PHAP25-00037

Date: September 18, 2025
Application Type: Certificate of Appropriateness
Property Owner: Raymond, Jonathan, and Jaedan Beard
Representative: Raymond Beard
Legal Description: 109 Government Hill 37 & 38 (6450 Sq Ft), City of El Paso, El Paso County, Texas
Historic District: Austin Terrace
Location: 4656 Caples Circle
Representative District: #2
Existing Zoning: R-4/H (Residential/Historic)
Year Built: 1941
Historic Status: Contributing
Request: Certificate of Appropriateness for installation of new windows after-the-fact
Application Filed: 9/4/2025
45 Day Expiration: 10/19/2025

ITEM #5

Certificate of Appropriateness for installation of new windows after-the-fact

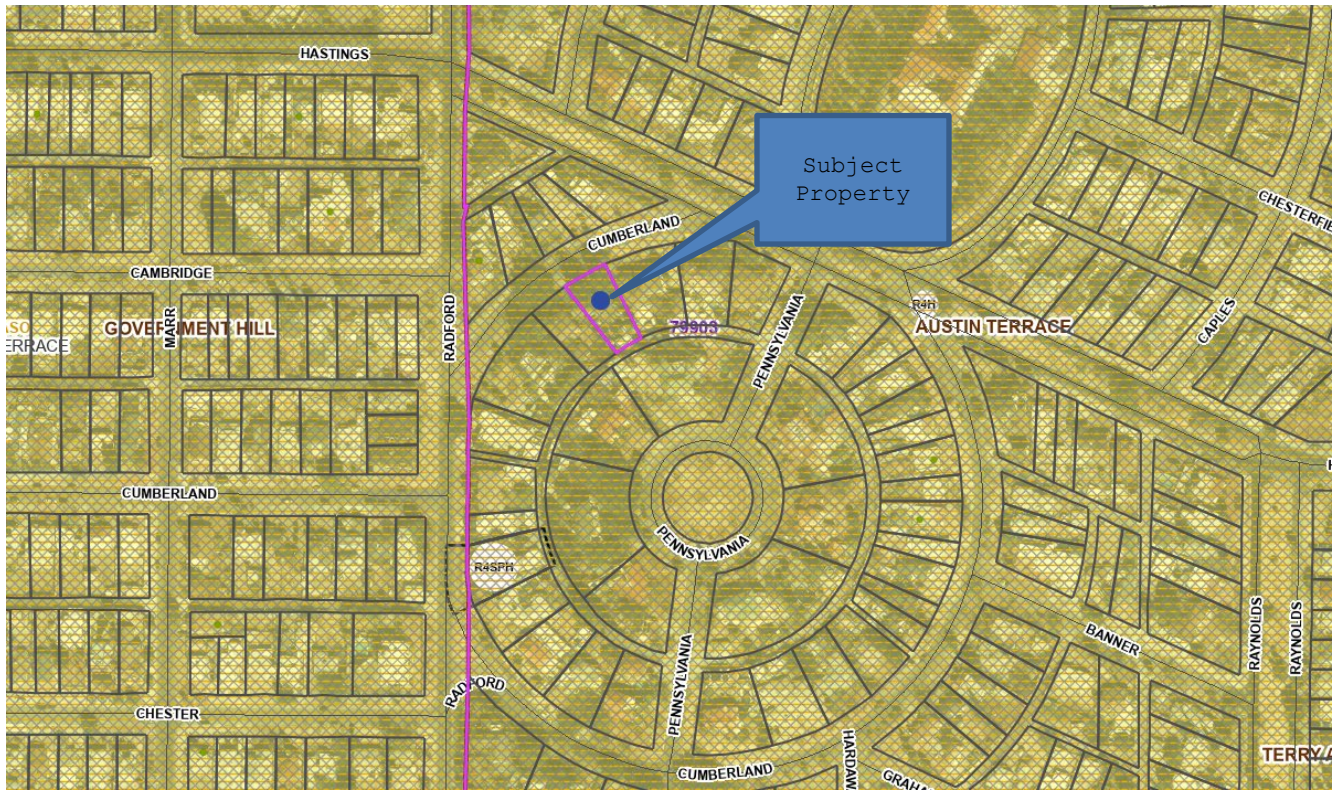
The Historic Preservation Office recommends APPROVAL WITH A MODIFICATION of the proposed scope of work based on the following recommendations:

- *However, if windows are damaged beyond repair, replacement windows should match the type (such as double hung), style (for example six panes over six panes), and finish (paint). Replacement windows on the main façade shall be comprised of the operable portions of the window and match the type, style, operation, configuration and finish of the original windows. Do not use single pane picture windows or horizontal sliding windows if they are not the original window types. Installation of windows similar to the original in appearance and structural purpose, regardless of construction materials is permitted. Windows in secondary facades shall be reviewed on a case-by-case basis.*

The modification is that the existing windows be replaced with operable windows matching the historic windows.
